**Davis Hall, Ground Floor Renovations**

**Project Number: SCSU-2023-02**

**ADDENDUM NO. 2**

**April 28, 2023**

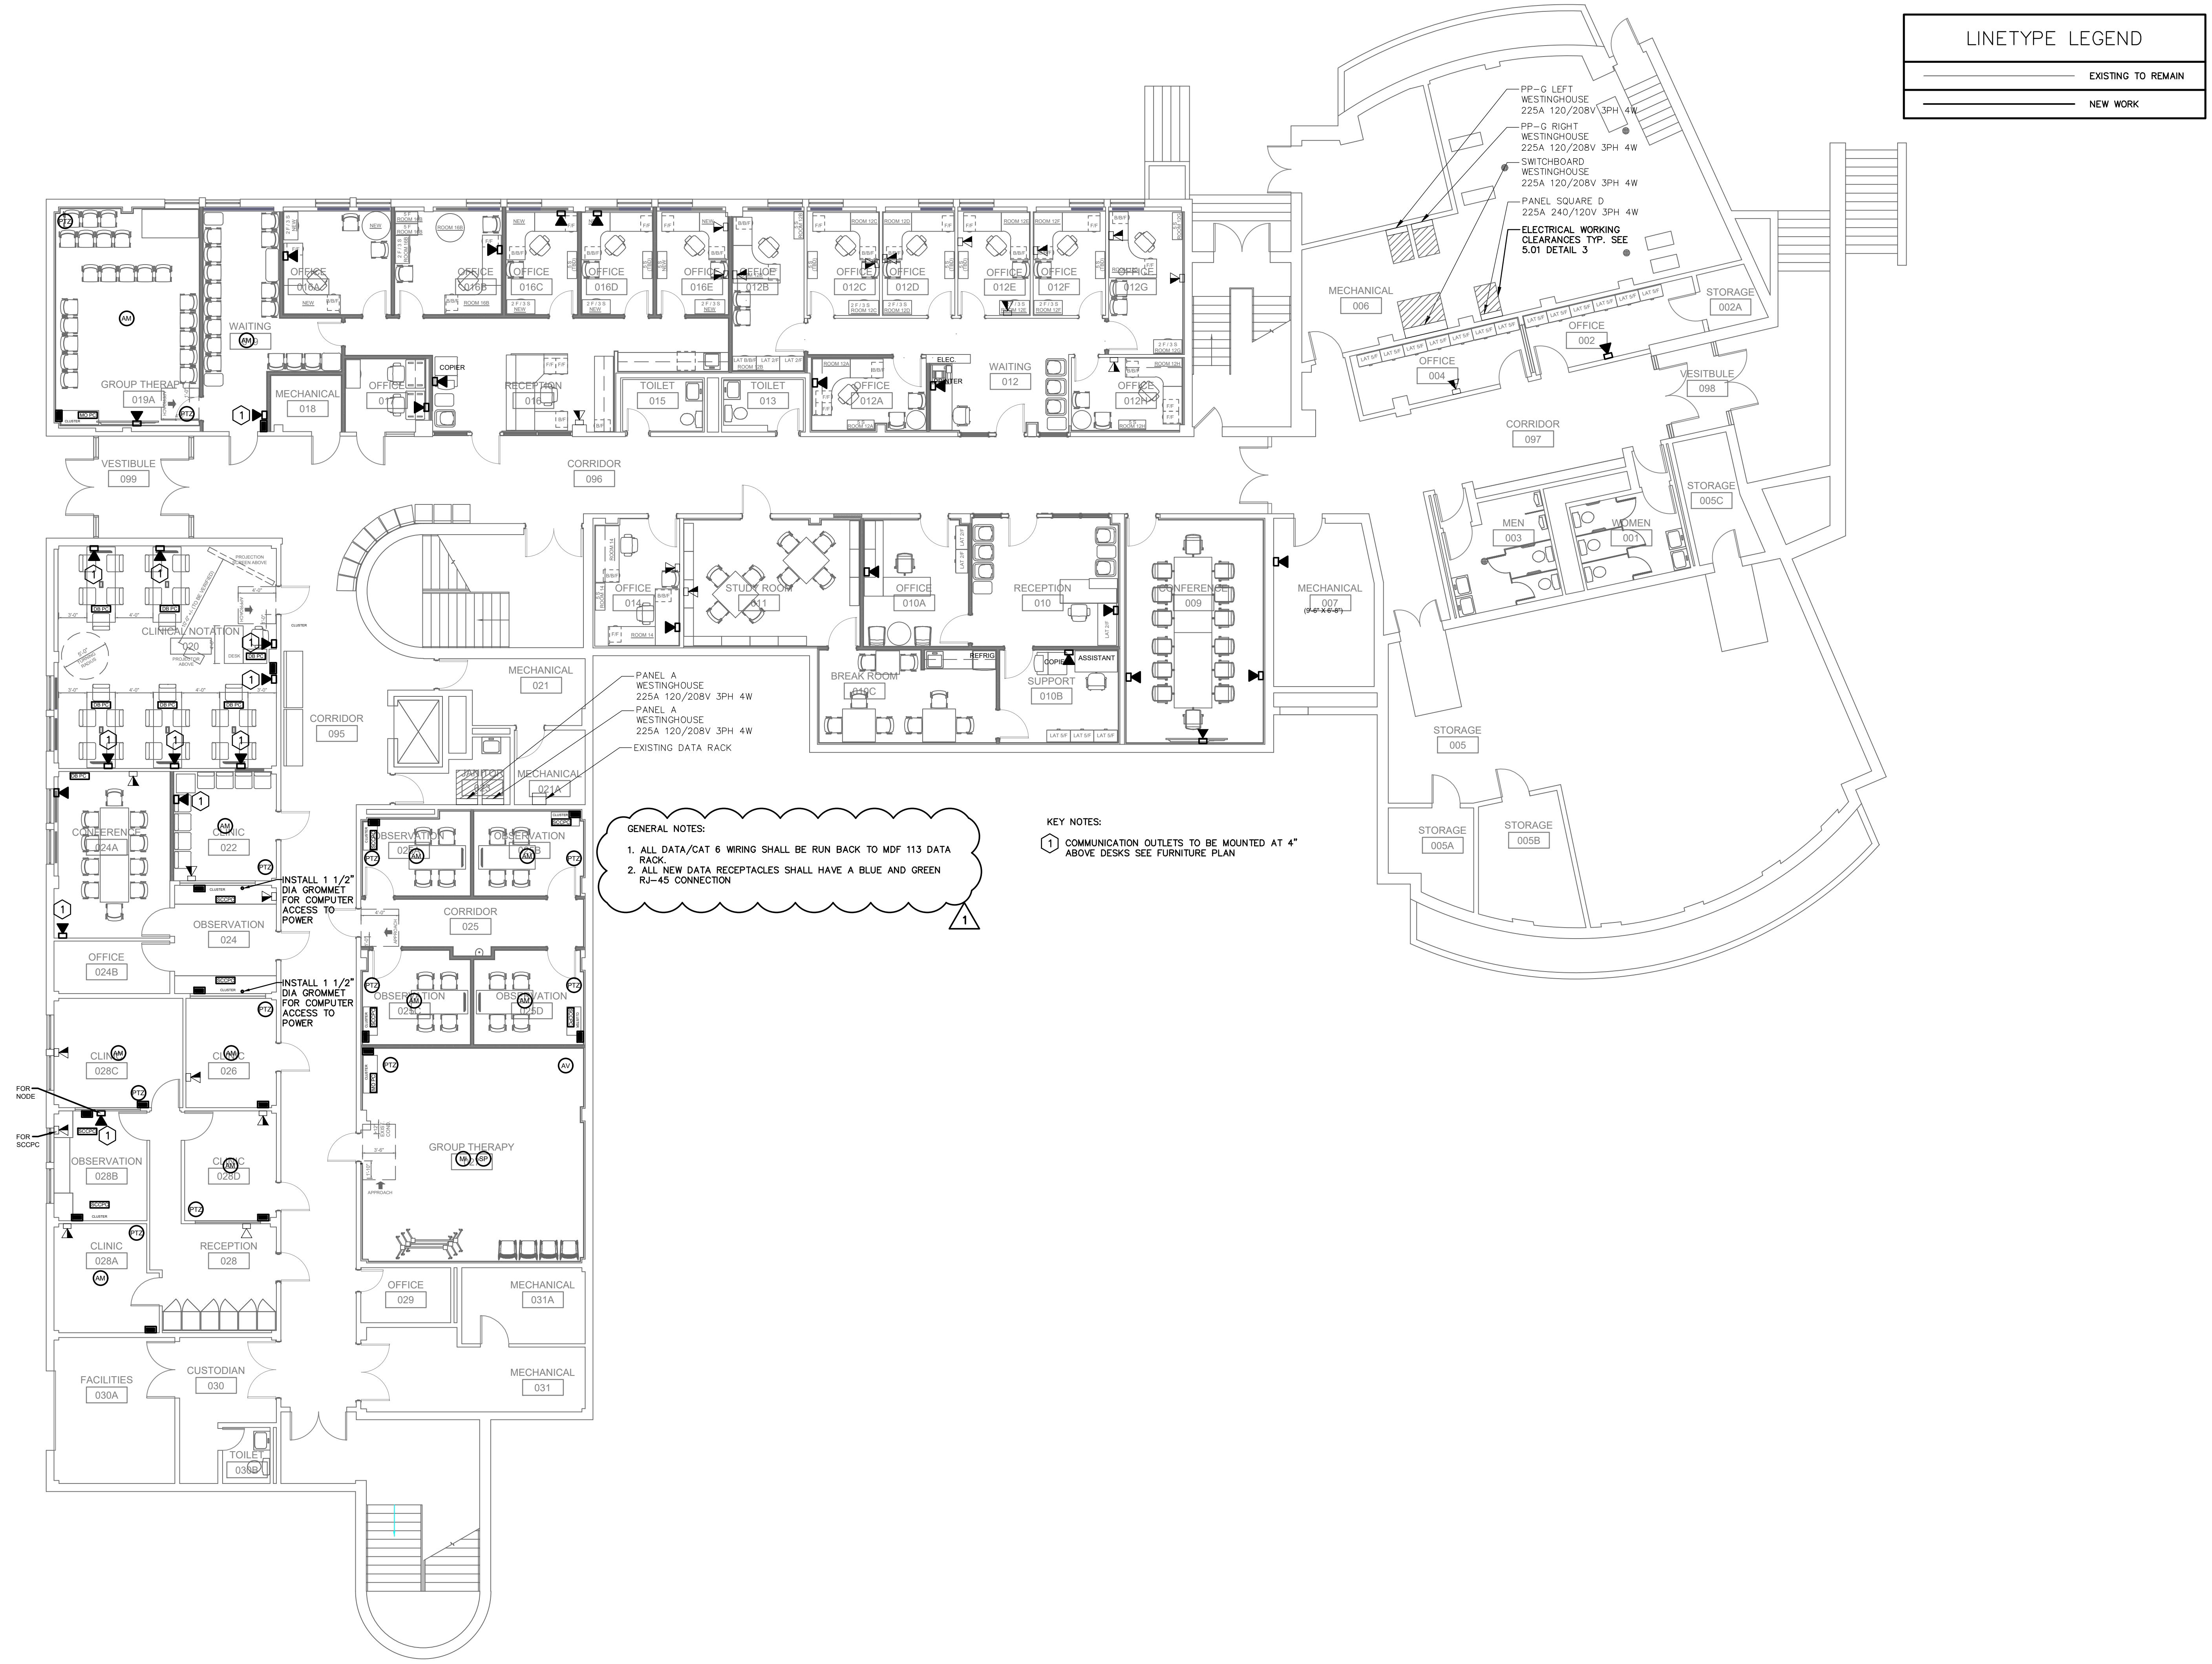
**Item 10 – DRAWING ETS1.01, DATA WIRING:**

All data wiring shall be run back to MDF 113 data rack located on the first floor.

1. ALL DATA/CAT 6 WIRING SHALL BE RUN BACK TO MDF 113 DATA RACK.
2. ALL NEW DATA RECEPTACLES SHALL HAVE A BLUE AND GREEN RJ-45 CONNECTION.
